| APPLICATION NO. | FILING DATE | FIRST NAMED INVENTOR | ATTORNEY DOCKET NO. | CONFIRMATION NO. |
|-----------------|-------------|----------------------|---------------------|------------------|
| 10/701,698 | 11/05/2003 | Ricardo Blank | N-32769A | 7089 |

Office Action Summary

DETAILED ACTION

FIG. 1

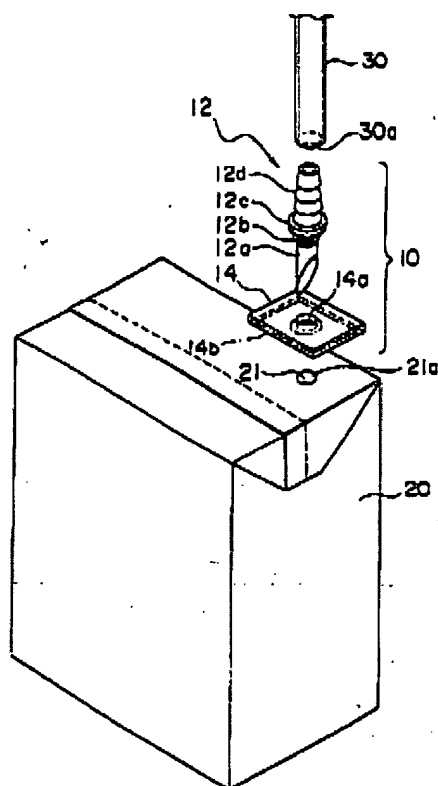
Regarding claim 2, Kawaguchi teaches a connector device (12) capable of use with and enteral administration set (30) having a feeding line (30), and a laminated paper packaging system (20) comprising:

means (12d) capable of fitting to an enteral administration set (30), including a connector (112) which comprises a rigid tube part (112) capable of attachment of a feeding line (30) of an enteral administration set (30), the tube part (112) containing part of the passageway (12g) for the composition to be administered,

means (12a) capable of fitting to the laminated paper packaging system (20), wherein the means (112a) capable of fitting to the laminated paper packaging system (20) comprises an internally threaded portion (112b, 112s) capable of being screwed onto a corresponding outwardly threaded portion (114s) of a frame-like member (114) of the laminated paper package system (20),

a passageway (12g) capable of allowing the flow of a composition contained in the laminated paper packaging system (20) from the laminated paper packaging system to the enteral administration set (30) through the connector device (12),

and wherein the connector device further comprises means (112a) for opening of the laminated paper packaging system (20) upon screwing the connector device (112) onto the frame-like member of the laminated paper packaging system (20)(page 11, lines 9-12)(see figures 1 & 6, *infra*).

FIG. 6

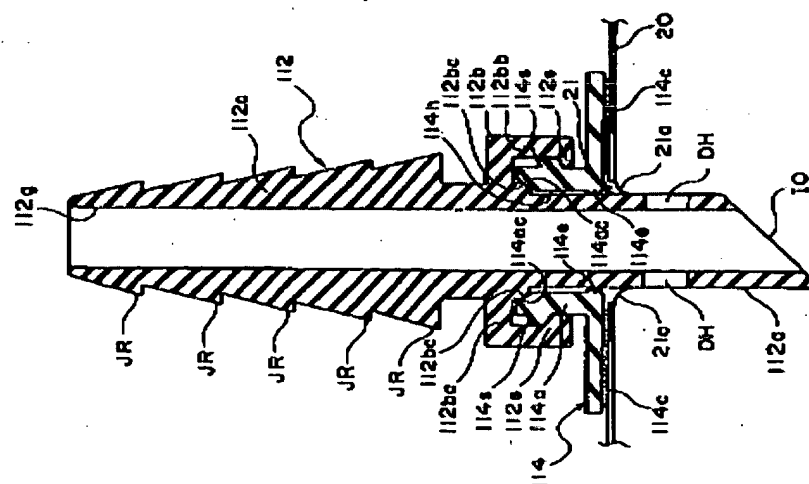
wherein the attachment means (14) for fixedly attaching the connector device (12) to the laminated paper packaging system (20) comprises a rim (112b) having an upper surface facing towards the laminated paper packaging system, an adhesive layer (14b) being provided on the upper surface for attaching the connector (12) to the laminated paper packaging system (20) upon penetration of the spike (12a) and pressing of the upper surface of the rim (112b) with the adhesive layer (14b) against the laminated paper packaging system (20)(see fig. 6, supra).

Regarding claim 19, the Kawaguchi's connector (12) requires significant force to remove from the enteral administration set (30) is interpreted herein as being relatively non-releasable compared to a connector that lacks barbs (JR)(fig. 6).

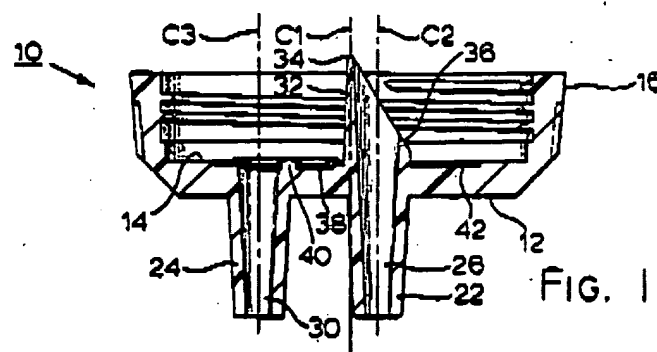
Dickerhoff teaches an enteral bottle cap (10) with a vent valve (24, 38) that permits entry of filtered air into the container while prevention liquid from exiting the container (see figure 1, *infra*). This provides for unimpeded flow of liquid through outlet (26).

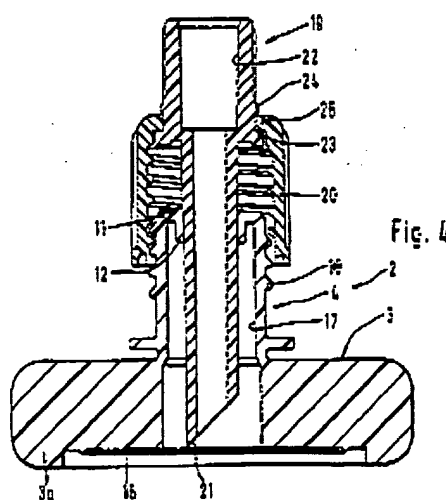
Regarding claim 20, Kawaguchi teaches a connector device (112) capable of connecting an end of a feeding line (30) of an enteral administration set (30) to a laminated paper packaging system (20) containing a composition capable of being administered through the set (30), wherein the packaging system (20) includes a surface and a tubular frame-like member projecting (114) from the surface, the frame-like member (114) defining a first threaded portion (114s), the connector device (112) comprising:

a rigid tube part (112c) capable of sealingly engaging the end of the feeding line (30), the tube part (112c) defining a first part (112c) of a passageway (112g) for the composition,

first means (112b) adapted to fit and attach the connector device (112) to the laminated paper packaging system (20), wherein the first means (112b) defines a second part (112b) of the passageway capable of allowing the composition to flow through the connector device (112) from the packaging system (20) into the feeding line (30), and wherein the first means (112b) includes a second threaded portion (112s) defined on the connector device (112), the second threaded portion (112s) being complementary to the first threaded portion (114s) of the frame-like member (114) of the laminated paper packaging system (20) such that the connector device (112) threadably engages the frame-like member (114) of the laminated paper packaging system (20); and

Kawaguchi does not teach a cutting member rotatable with the connector device upon screwing the connector device onto the frame-like member of the packaging system, the cutting member projecting toward the surface such that the cutting member is capable of first cutting the surface only after engagement of the second threaded portion of the connector device with the first threaded portion of the packaging system.
